SS 1033403 - WST Wiper Motor not Parking Issues

WST 4700, 4800 and 4900

Below are shown the locations of the Gnd Terminal Aux PDM Bracket and P12 Wiper Motor Gnd 1 Cav Connector.

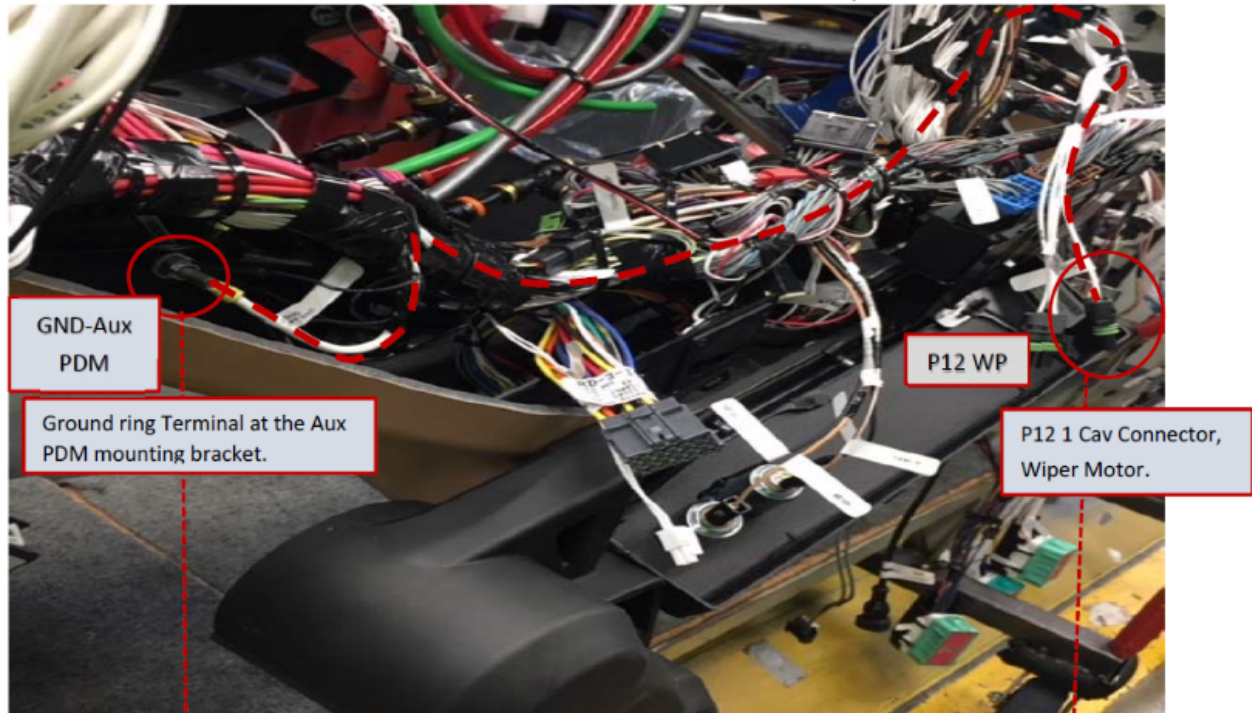
Ground connection not effective or presenting a higher than recommended resistance path.

It has been tested in the field that the addition of a solid ground to the Wiper Motor Connector Ground resolves the issues.
